Access Compliance Report

Public Rights-of-Way

(Curb Ramps)

Intersection ID: 9651	Main Street: CRESTVIEW_DR	Cross Street: MATTOON_ST	Location: NE
ADA ID: 355190F2E7DE	Ramp Type: PerpDiag	Initial Pass/Fail: Fail	Overall Compliance: No
Codes/Mitigation Info/Possible Solution			Severity Score: 10
			Field Measurements/Component Compliance

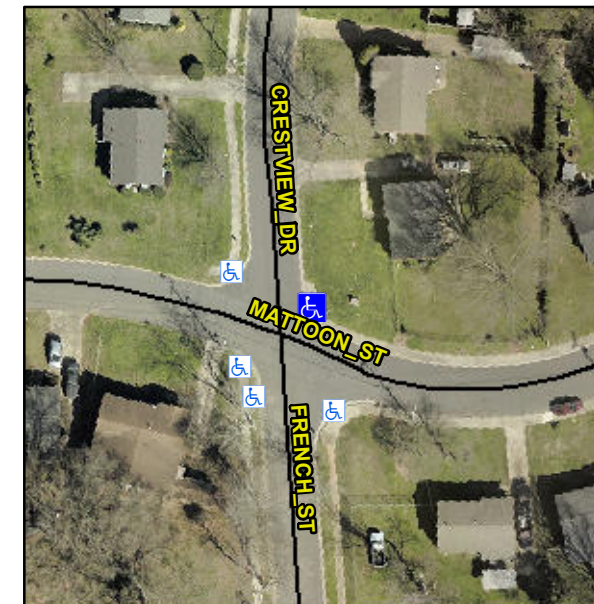
Not Found, R304.5.1, R304.5.3

Compliance	Description	Data	Compliance	Description	Data
N/A	Ramp Length (in)	61.5	Yes	Ramp Slope (%)	5.7
No	Ramp Width (in)	47.5	No	Ramp XSlope (%)	4.7
N/A	Flare Type LT	N/A	N/A	Flare Type RT	N/A
N/A	Flare Slope LT (%)	N/A	N/A	Flare Slope RT (%)	N/A
N/A	Flare Traversable LT?	N/A	N/A	Flare Traversable RT?	N/A
N/A	Landing Length (in)	N/A	N/A	DWS Provided?	N/A
N/A	Landing Width (in)	N/A	N/A	DWS Contrast?	N/A
N/A	Landing Slope (%)	N/A	N/A	DWS Length (in)	N/A
N/A	Landing X Slope (%)	N/A	N/A	DWS Full Width?	N/A
N/A	Landing Curb? (Y/N)	N/A	N/A	DWS Offset (in)	N/A
N/A	Shared Landing?	N/A			
N/A	Gutter Ponding?	N/A	N/A	Gutter Slope (%)	N/A
N/A	Gutter Lip Ht (in)	N/A	N/A	Gutter X Slope (%)	N/A
N/A	Painted X Walk1?	No	N/A	Painted X Walk2?	No
	X Walk 1 Direction	To W		X Walk 2 Direction	To S
N/A	X Walk 1 Width (in)	N/A	N/A	X Walk 2 Width (in)	N/A
	X Walk 1 Slope (%)	5.3		X Walk 2 Slope (%)	6.1
	X Walk 1 X Slope (%)	3.9		X Walk 2 X Slope (%)	3.6

Remove & Replace Curb Ramp With Two New Directional Ramps or Equivalent.
